**Compliance with Approval Condition (a)
Planning Application No. A/HSK/425**

**Proposed Temporary Shop and Services for a Period of 5 Years in “Village Type Development”
Zone, Lot 1583 (Part) in D.D. 125, Tin Ha Road, Hung Shui Kiu, Yuen Long, New Territories**

Appendix I – Response to the Comments of Chief Engineer/Mainland North, Drainage Services Department (CE/MN, DSD)

Fig.1

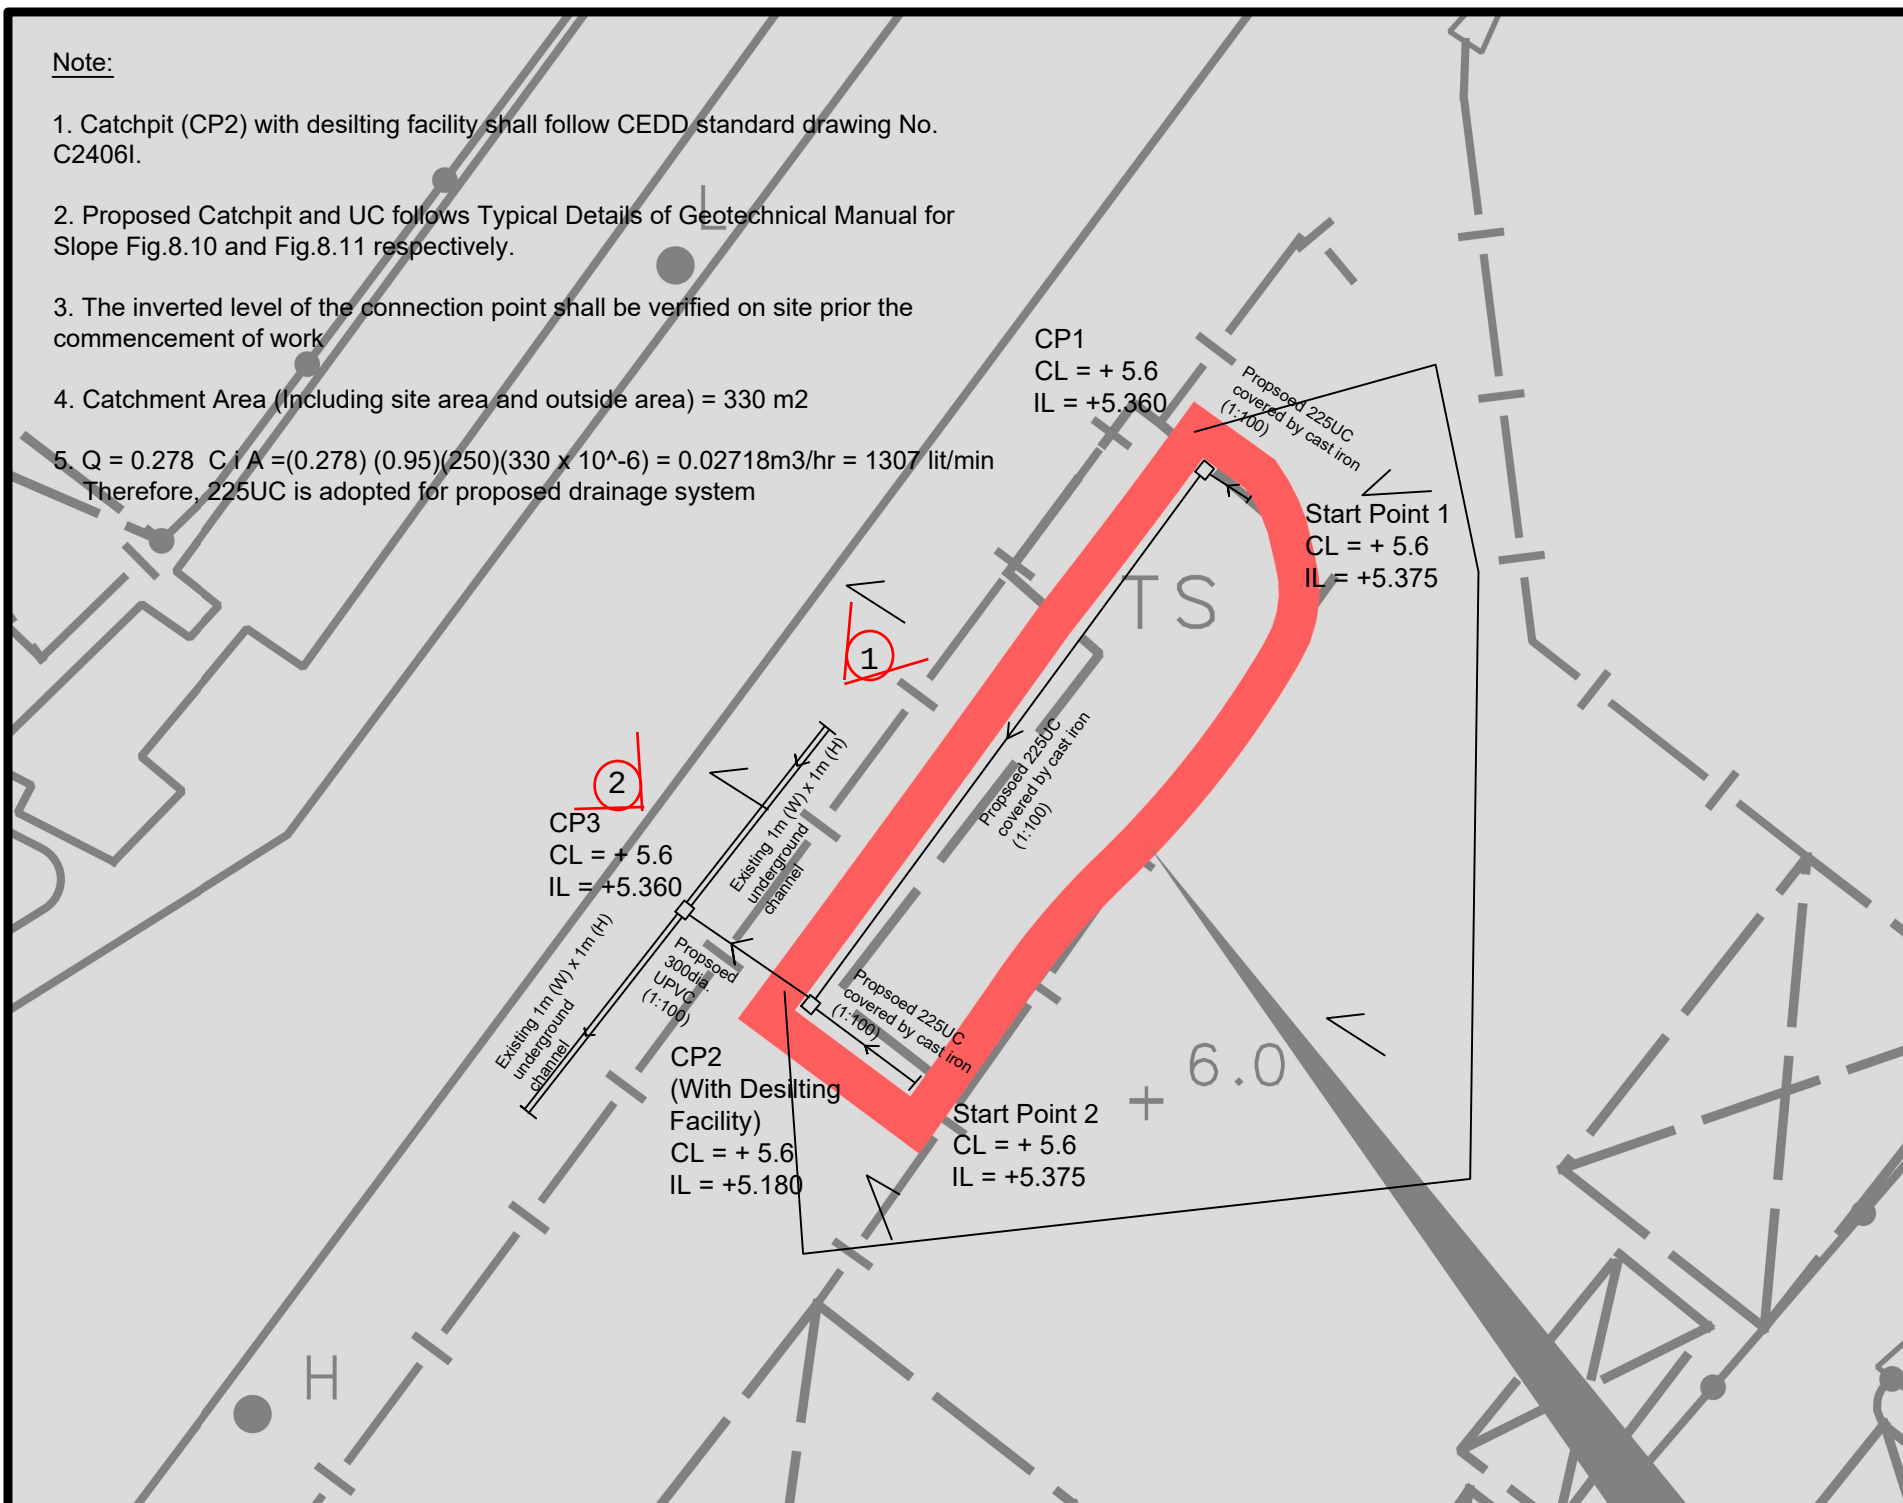
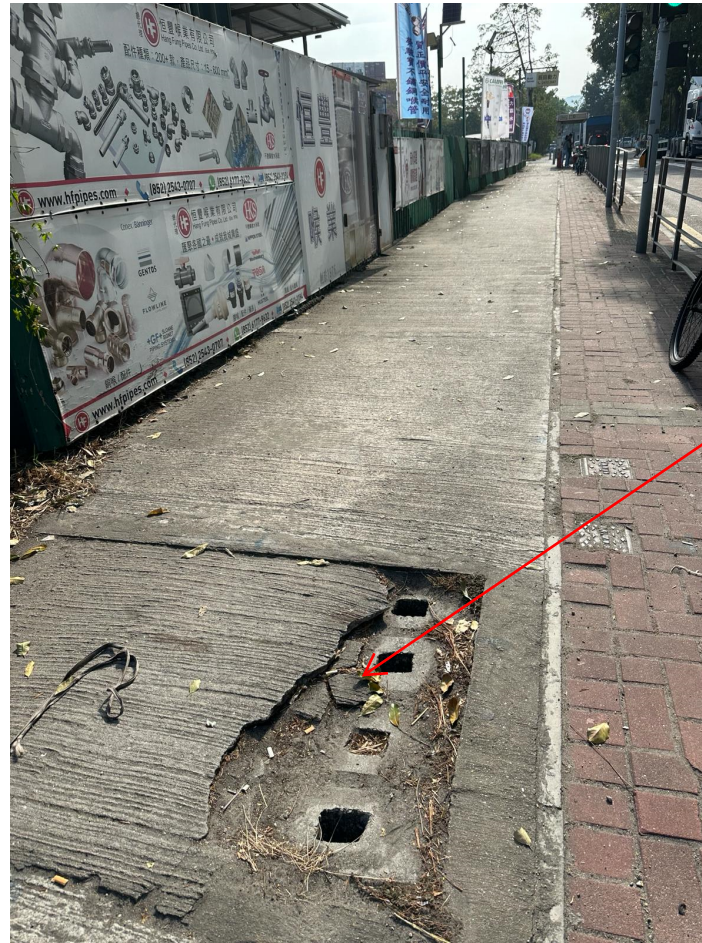
Comments of the CE/MN, DSD (Contact Person: Ms. Vicky SY; [REDACTED])		
	Based on our record, the existing 700mm diameter pipe which the proposed drainage system to be discharged to is removed / not function anymore. Please review.	Final discharge point (i.e. the existing 700mm diameter pipe) is revised to the existing 1m x 1m underground channel. Photographic records showing the existing drainage facilities are provided at the revised drainage proposal for your reference (Appendix II).
